**NORTH CAROLINA
DEPARTMENT OF ENVIRONMENT AND NATURAL RESOURCES
DIVISION OF AIR QUALITY**

**BEST AVAILABLE RETROFIT TECHNOLOGY
PRELIMINARY DETERMINATION**

**BLUE RIDGE PAPER PRODUCTS
CANTON, HAYWOOD COUNTY
NORTH CAROLINA**

Response to EPA and NPS Comments on BART Permit Application

Figure No. 1 – Overview of the Canton Mill

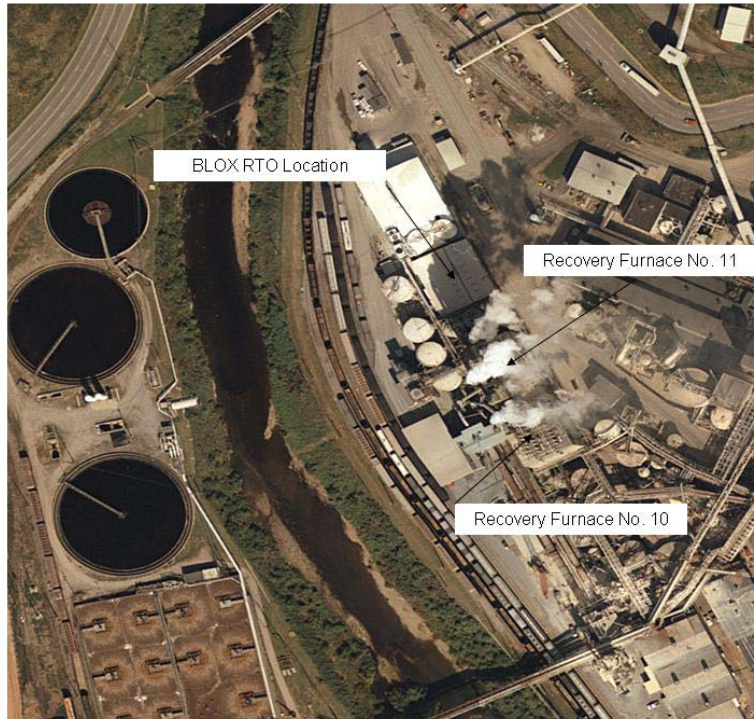
Table 4-2 describes costs with wet scrubber installation on one of the RFs. Given the relatively high nature of costs for the modifications to existing ductwork and installation of a new stack, fan, and switch gear (totaling to \$11,945,605), consideration should be given to other, more cost effective options. For example, the feasibility and cost effectiveness of moving the road or other buildings to allow closer location of the wet scrubbers and avoid extensive ductwork could be considered.

To assist in understanding the unique situation at Blue Ridge, we have included an aerial photograph of the site. As you will note, the mill is located in the heavy industrial area within the Town of Canton. Mill property is extremely limited and the options proposed in the comments are not feasible. The roads cannot be moved due to fire regulations and there are no buildings to be moved.

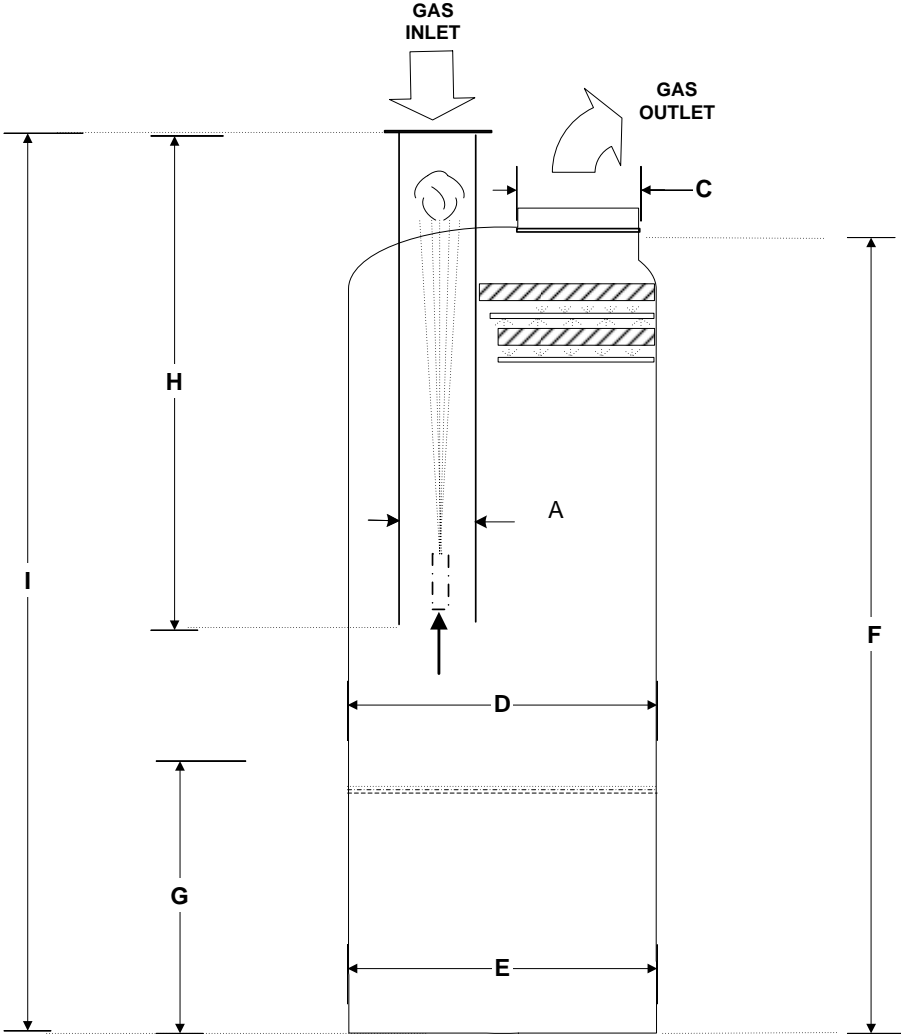
It would be helpful to have more information on the design of the wet scrubber analyzed. We are aware of at least one kraft pulp mill (i.e., the James River Camas Mill in Washington State) that has installed a cross-flow, packed bed scrubber following the RF electrostatic precipitator (ESP) as part of an energy recovery system. At that mill, caustic (sodium hydroxide or NaOH) is added to the scrubber liquid and the mill has claimed SO₂ reductions as a result. It is not clear whether the facility has considered installing a similar system.

There are many scrubber configurations commercially available. We have evaluated the MECS Reverse Pulse Jet system. While the cost for the scrubber itself is significant, the largest cost contribution is from the installation of ductwork to route the exhaust to the unit and modifications to the fan and switch gear. These costs would be approximately the same no matter the scrubber design.
